**Amendment-3 (dated:19.04.2024) to RFP Documents for “Transmission System under Provision of Dynamic Reactive Compensation at KPS1 and KPS3” through tariff based competitive bidding process.**

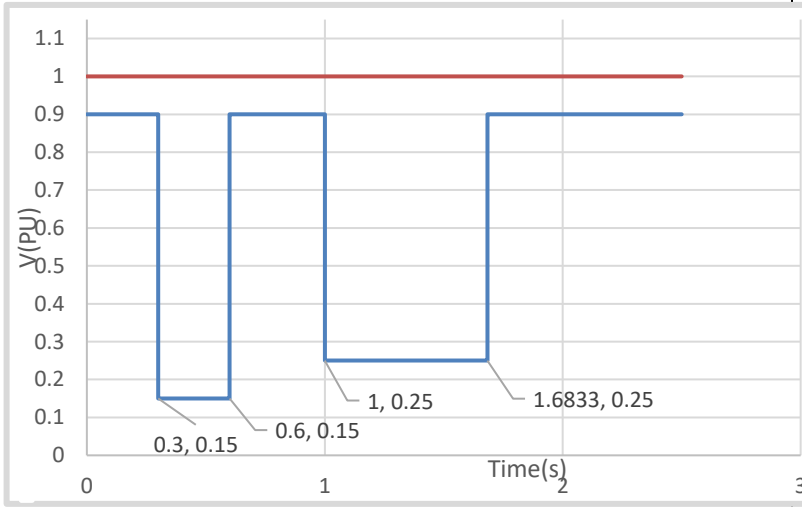
7.	<b>Power System Characteristic of STATCOM</b>	<p><i>The STATCOMs shall remain connected to the grid and shall be able to operate at rated reactive power capability when voltage at the interconnection point, on any or all phases dips up to the level depicted by the thick lines in the following curve (for specified time):</i></p> <p style="text-align: center;">VT : Actual Voltage; Vn: Nominal Voltage</p>	<p><b><i>For STATCOMs near RE complex:</i></b></p> <p><i>The STATCOMs shall remain connected to the grid and shall be able to operate at rated reactive power capability when voltage at the interconnection point, on any or all phases dips up to the level depicted by the thick lines in the following curve (for specified time):</i></p> <p style="text-align: center;">VT : Actual Voltage; Vn: Nominal Voltage</p>

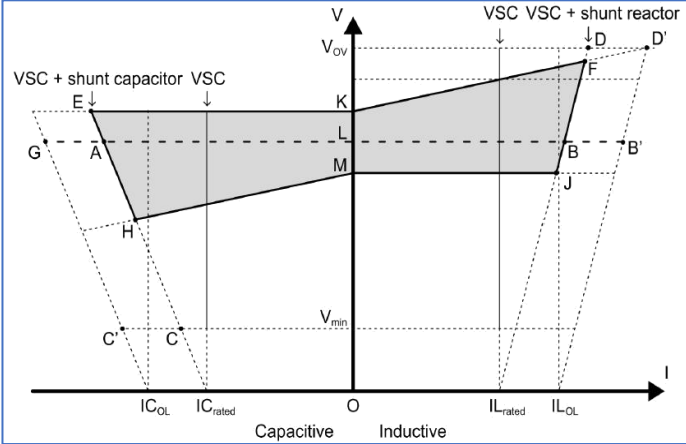
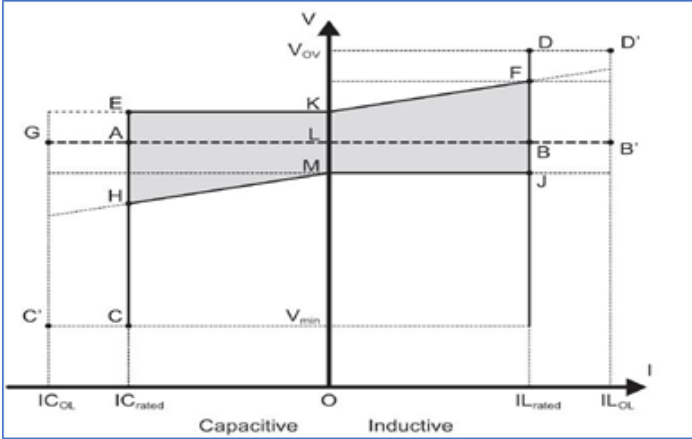
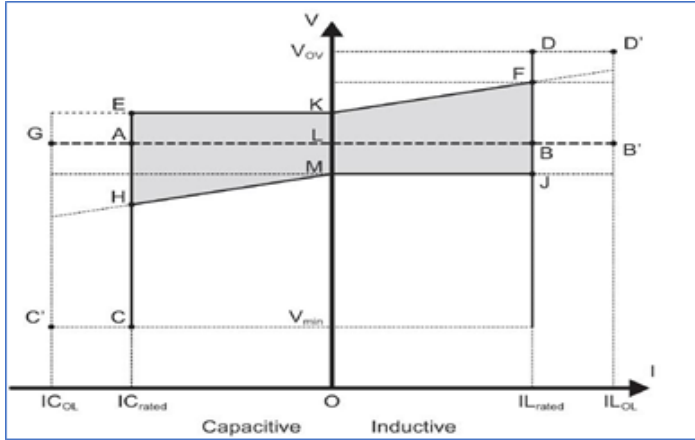
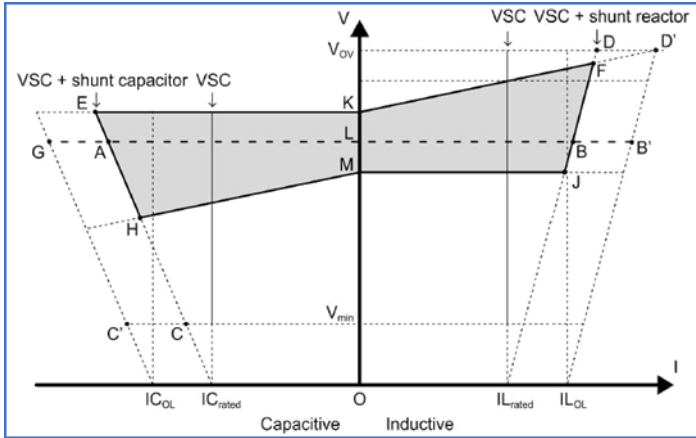
Sl. No.	Clause No.	Existing Clause	New/Revised Clause
16.	A.6 STATCOM Station Characteristics	 <p><b>Figure-2: VI Curve of the VSC Portion</b></p>  <p><b>Figure-3: VI Curve of the STATCOM Station</b></p>	 <p><b>Figure-2: VI Curve of the VSC Portion</b></p>  <p><b>Figure-3: VI Curve of the STATCOM Station</b></p>
